Docket Number:	14-AAER-02
Project Title:	Computer, Computer Monitors, and Electronic Displays
TN #:	211225
Document Title:	California Investor Owned Utilities Comments: Electronic Displays - Response to Staff Report
Description:	Title 20 Displays Workshop 2016-04-26
Filer:	System
Organization:	California Investor Owned Utilities
Submitter Role:	Public
Submission Date:	4/25/2016 8:44:18 AM
Docketed Date:	4/25/2016

Electronic Displays

Response to Staff Report

Presented to the California Energy Commission

Complying Monitors: 17-inches and Larger

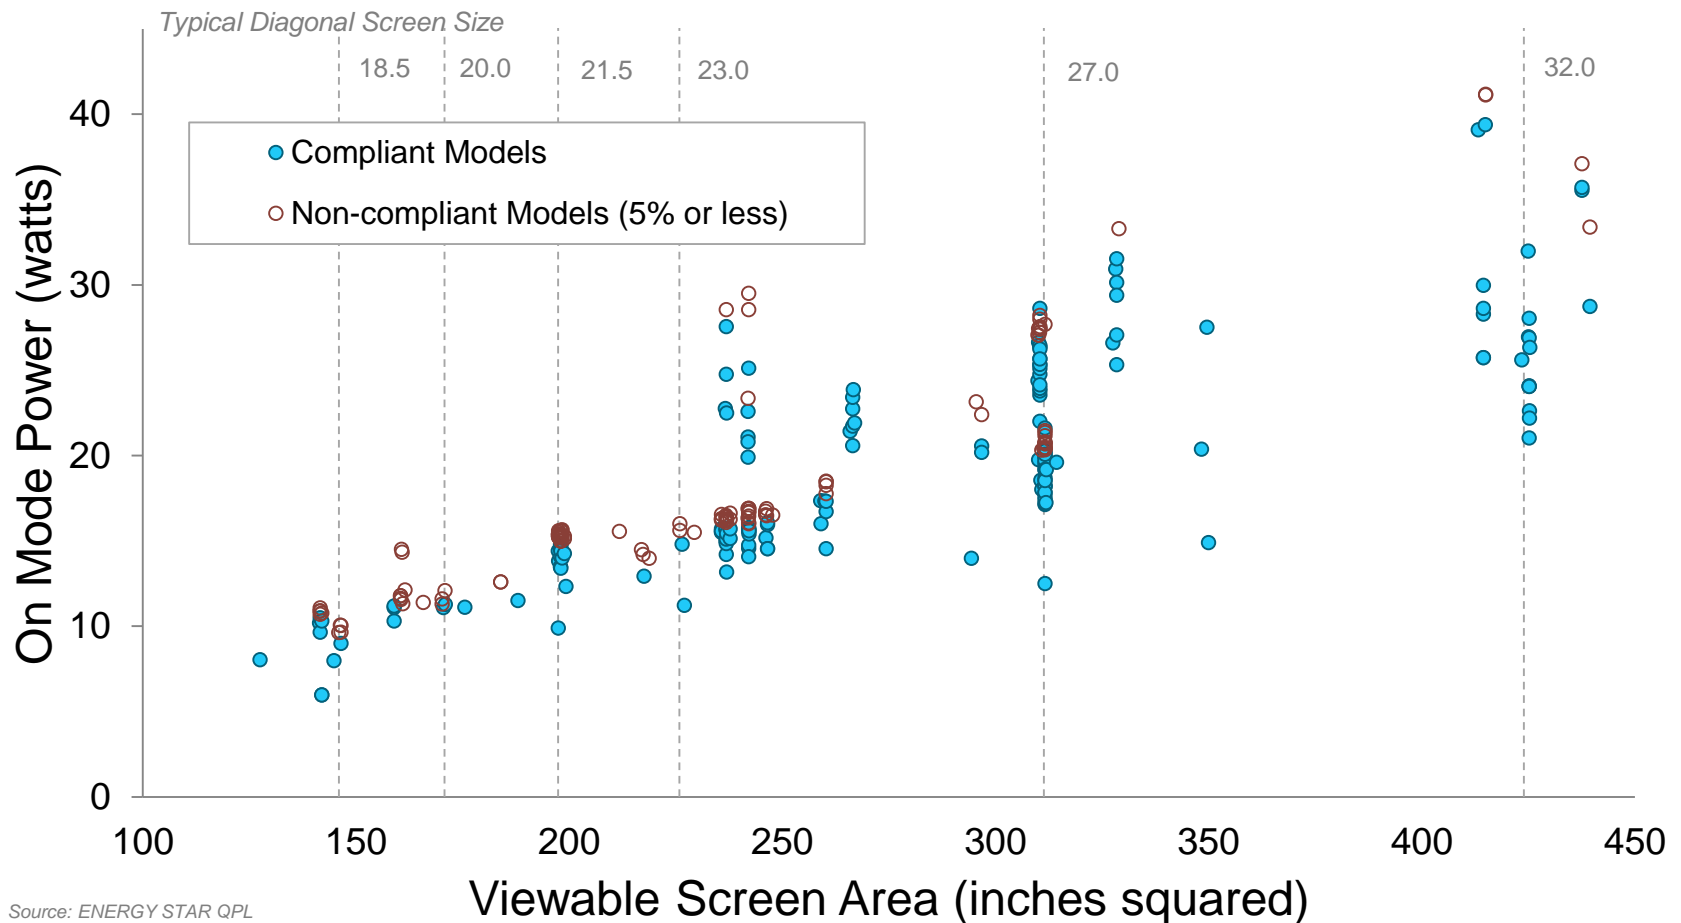
On Mode Levels are Feasible

169 models across all sizes available today would meet levels

- 20 manufacturers represented
- Various resolutions (1.05 to 8.29 MP) and features
- All panel types: IPS, TN, VA
- Wide range of price points: \$130 to \$1,300

121 models would need to make improvements of 5% or less to meet proposed standard

- Low to no cost efficiency improvements, e.g., reflective polarizer film, higher efficacy LEDs, improved power supplies

- Comply today: 169 models
- Within 5% of limit: 121 models

IOUs Support Constant Resolution Allowance for > 5 MP

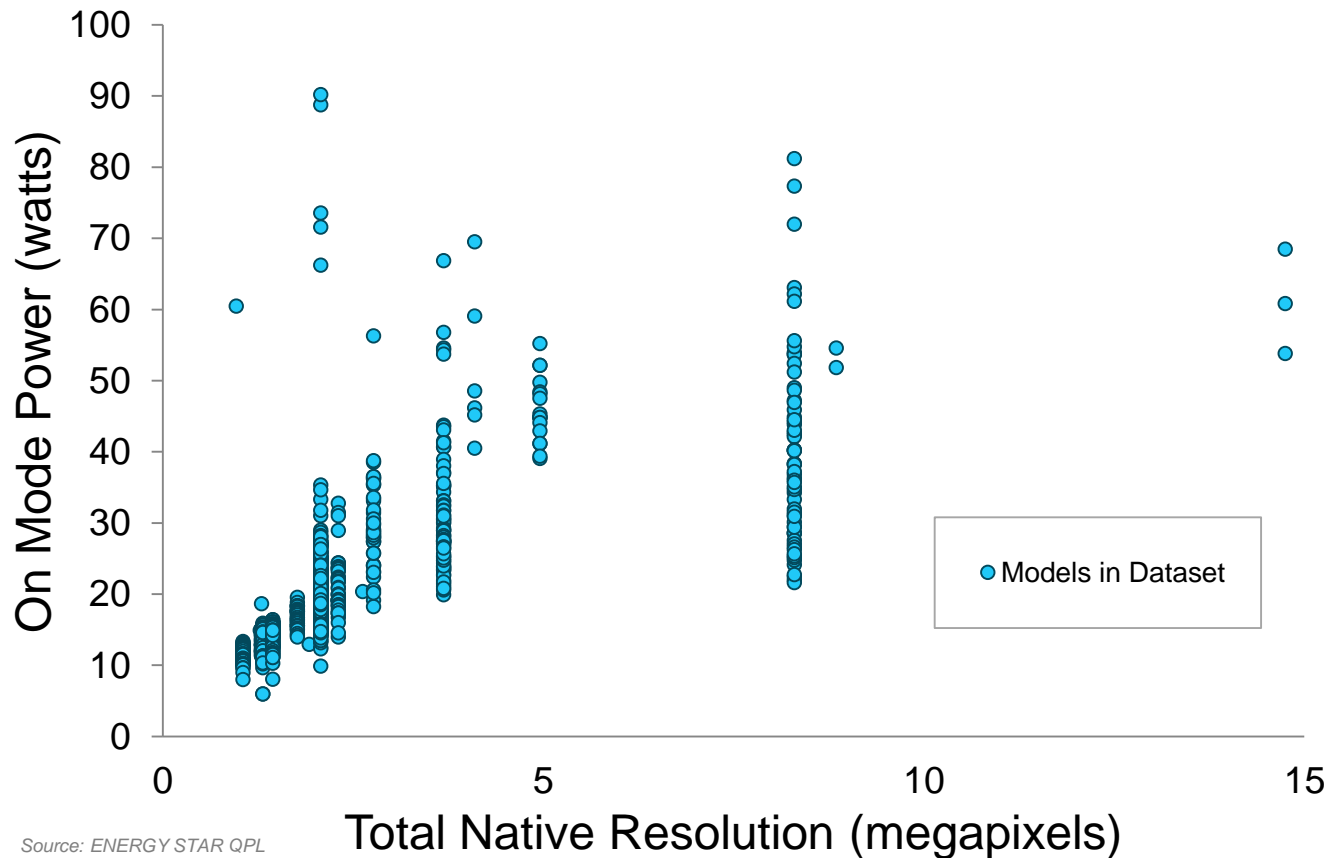
- Incremental power demand decreases with increasing resolution
- Constant allowance prevents lenient level without changing form of equation

IOUs Support Constant Resolution Allowance > 5 MP

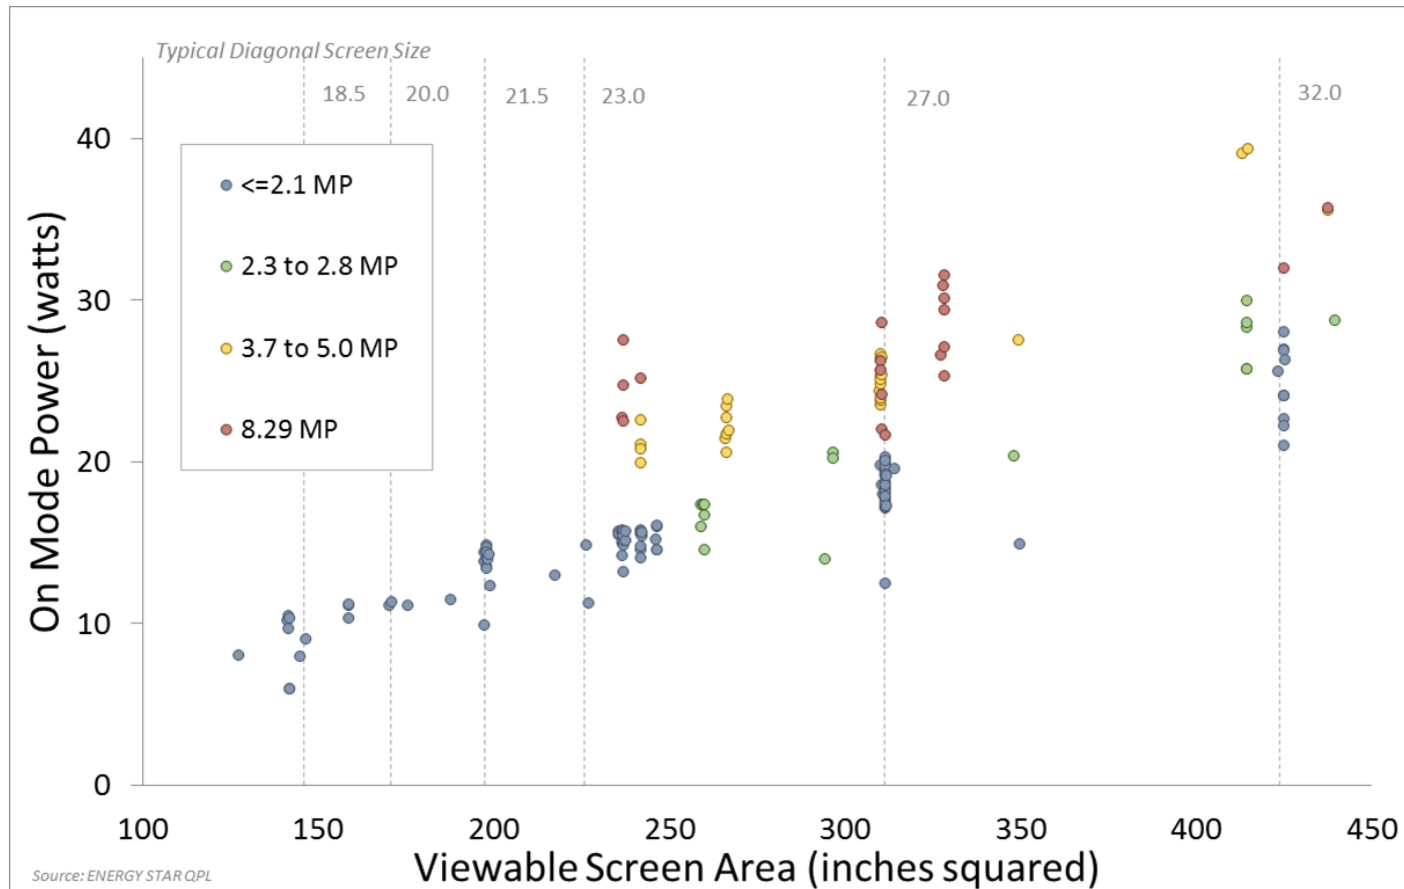
- Several examples of high resolution (8.3 MP) models being able to meet CEC's proposal
- Chart shows all models that meet CEC's proposal

IOU Propose New Size Bin to Limit Power Consumption at Largest Sizes

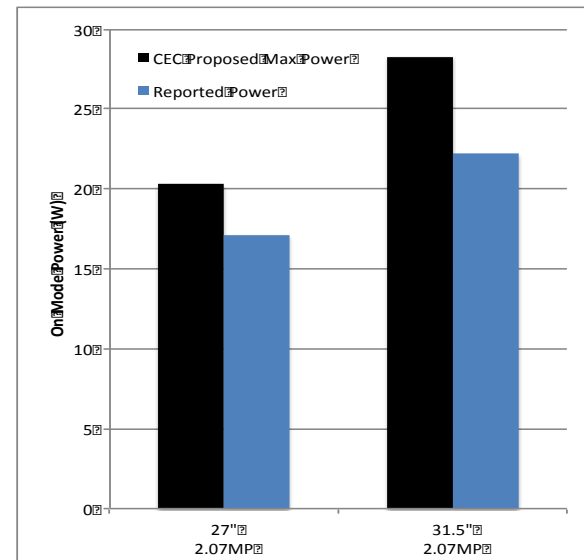
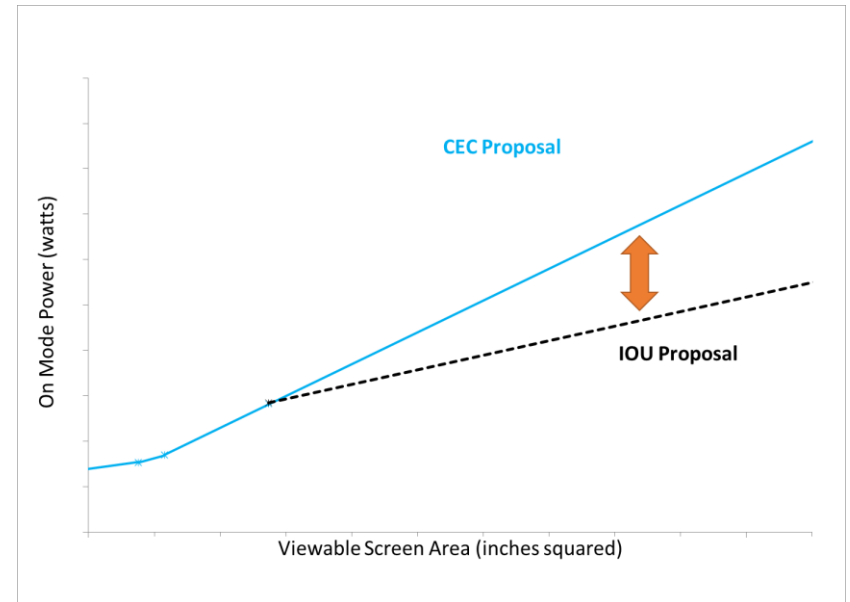
- As screen sizes get larger, IOUs propose reducing the slope of the On Mode limit for the largest sizes
- CEC's proposal is too generous for displays over 25"
- Larger monitors don't need proportionally larger allowance (the slope of the power vs screen size should decrease with increasing size)
